City of Mississauga Department Comments

File(s): A298.23 Ward: 1

Consolidated Recommendation

Property Address: 1515 Applewood Road

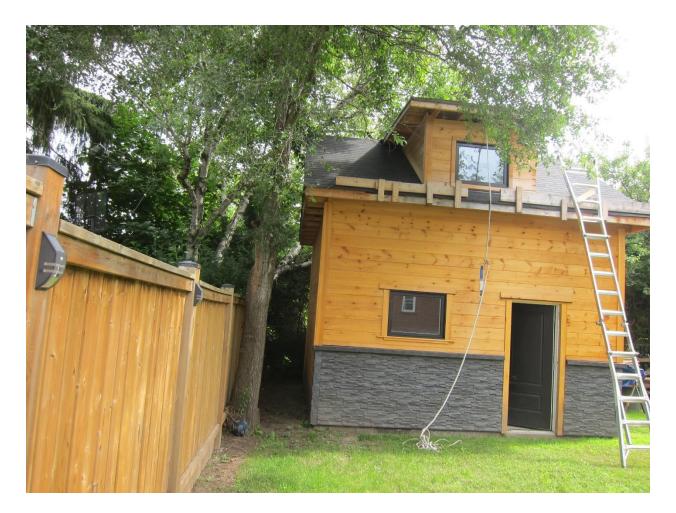
Attached are photos of the existing shed with attic space. We are noting for Committee's information that any Transportation and Works Department concerns/requirements for the proposed accessory structure and detached garage are being addressed by our Development Construction Section through the Building Permit process BP9 NEW-23/5560.
